WCAP-16943-NP-A
Revision 0

Enhanced GRCA Rodlet Design

| A | Letter from Bruce M. Bovol (NRC) to J. A. Gresham (Westinghouse), "Westinghouse Electric Company's Final Topical Report Safety Evaluation for WCAP-16943, 'Enhanced Gray Rod Cluster Assembly Rodlet Design,'" dated July 12, 2012. |

Figure 4.2-2 Specific heat of tungsten

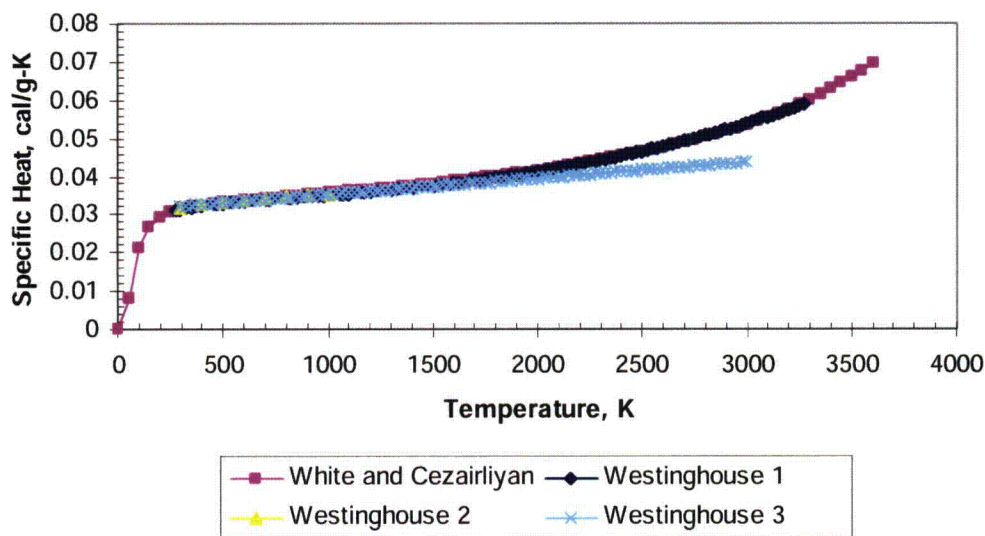
Since the applicant gave three different correlations for specific heat of tungsten, the staff asked in RAI-02 (Reference 2) which of these correlations is used in the safety analyses. The applicant responded that there are no analyses that use the correlations for specific heat. This response is acceptable since it has no impact on any applicable safety analysis, but does provide additional general description of the material properties for tungsten found in open literature.

Figure 4.2-7 W/Os phase diagram

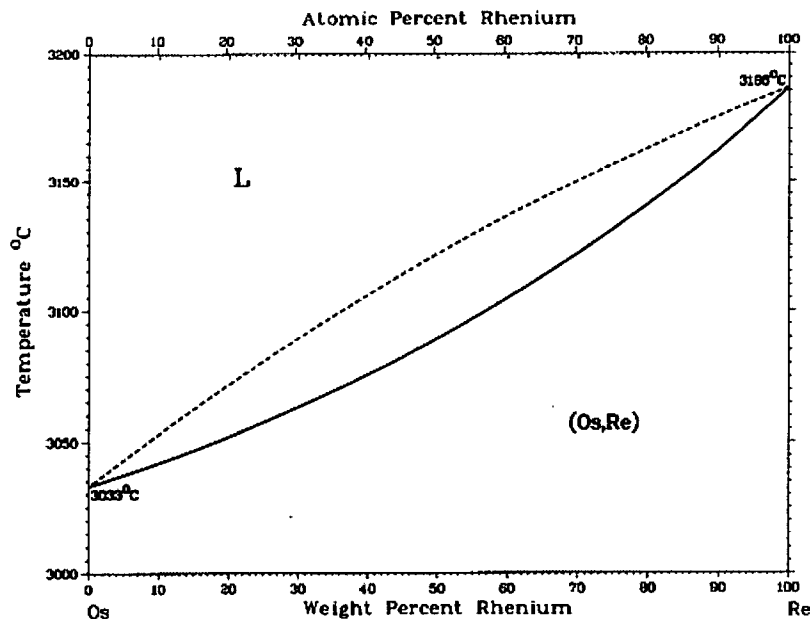
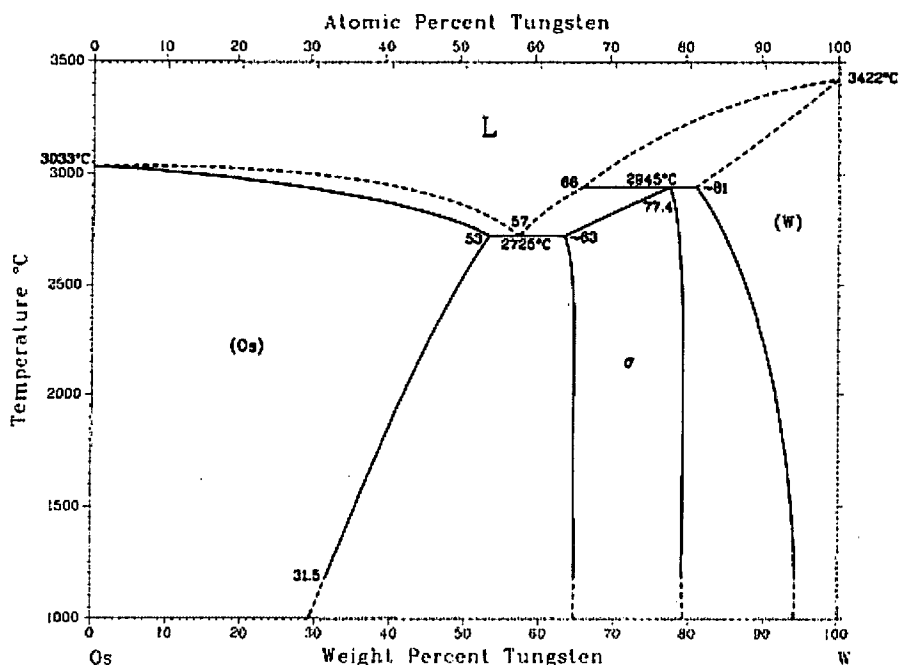
The staff noted that osmium (Os) is also formed throughout the service life of the GRCA rodlet. It is predicted that the maximum osmium content at end of life will be []. Figure 4.2-6 shows the Re/Os phase diagram, which demonstrates that rhenium and osmium are mutually soluble in each other at all compositions (Reference 17). Figure 4.2-7 shows the W/Os phase diagram, which demonstrates that osmium is only soluble in tungsten up to 6 wt% (Reference 17). [] The staff asked

in RAI-05 for the applicant to discuss the impact of buildup of osmium on the material properties of irradiated tungsten. The applicant responded (Reference 2) by noting that the osmium content []. The applicant also referenced a paper that stated that exceeding the osmium solubility limit is expected to cause a slight decrease in lattice parameter which would cause slight shrinkage of the material rather than swelling. This response demonstrates that the structural integrity of the sleeve is not compromised by the build-up of Os and is therefore found to be acceptable.

Figure 4.2-8 Radiation swelling in tungsten and W-25Re

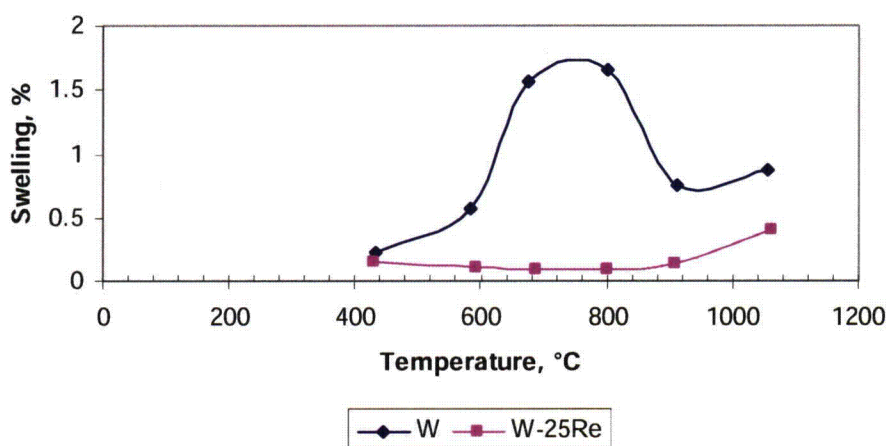
The applicant provided irradiation data for tungsten and W-25Re alloy to high fast fluences [] in the submittal. These data can be seen in Figure 4.2-8. These data demonstrate that the radiation swelling at [] will be a maximum of [], corresponding to a length change of []. The staff noted that the lowest temperature at which the swelling data was taken was 430°C. The staff is aware of some materials such as SiC that have more severe swelling at lower temperatures than at high temperatures since vacancies and interstitials are not annealed out as rapidly at low temperatures. The staff asked in RAI-04 that the applicant provide an estimate of the tungsten absorber at normal operating conditions and, if this temperature is less than 430°C, that data be provided to justify the assumption of [] over the expected range of operating temperature. The applicant responded (Reference 2) that in evaluating the absorber swelling, [] would be used based on that measured in the tungsten at []. This is conservative since the maximum tungsten temperature is expected to be [] swelling in pure tungsten of [], and swelling appears to decrease with rhenium additions due to transmutation. The applicant addressed the concern over low temperature swelling with an argument that swelling in refractory metals such as tungsten only occurs where the temperature is greater than 0.3 times the melting temperature. Based on the [] assumptions used by the applicant and inherent reduction in swelling with rhenium additions, the staff concluded that the applicant's response is acceptable.

FIGURE 4.4-1 Swelling of tungsten (circles) and W-25%Re (squares) by immersion density measurement at a fluence of 5.5×10^{22} n cm⁻² neutron fluence ($E > 0.1$ MeV) (1×10^{22} n cm⁻² neutron fluence ($E > 1$ MeV)) in the EBR-II reactor (Ref. 37)

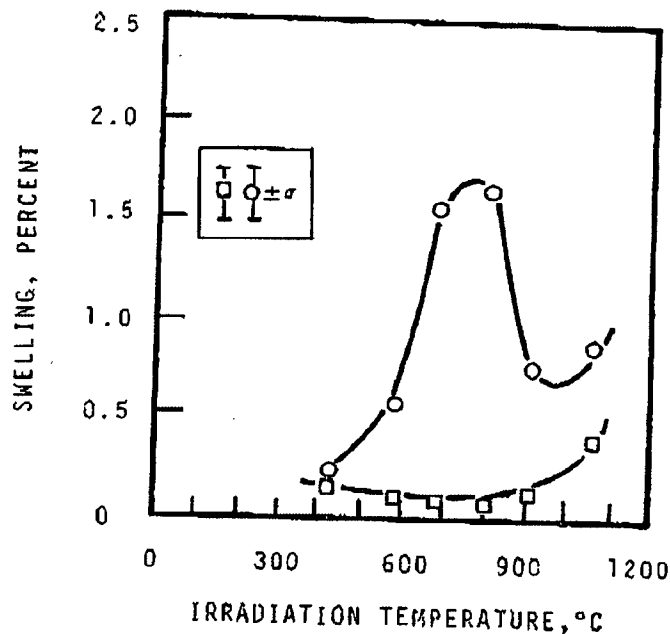
RAI 4. Figure 4.4-1 shows swelling data for W and W-25% Re. What is the expected operating temperature of the W? It has been observed for some materials that swelling increases with decreasing temperature due to a lack of annealing at lower temperature. If the expected operating temperature is below 430°C, what data can be used to justify the assumption that linear swelling will be less than that calculated?

The expected range of operating temperature for the tungsten absorber in the GRCA is from []^{a,c} depending on host assembly power and GRCA position. In evaluating the anticipated absorber swelling []^{a,c}, the temperature []^{a,c} in Figure 4.4-1 of WCAP-16943-P was used. []^{a,c}

[]^{a,c} The data from Figure 4.4-1 is in the form of volumetric swelling. Diametral swelling is 1/3 of the value for the isotropic volumetric swelling expected for tungsten.

Thus, the swelling value used for mechanical evaluations bounds tungsten irradiation swelling over the temperature range from []^{a,c}. Below 430°C (lower bound of the data in Figure 4.4-1 of WCAP-16943-P), the temperature is too low to produce recordable swelling, as stated below.
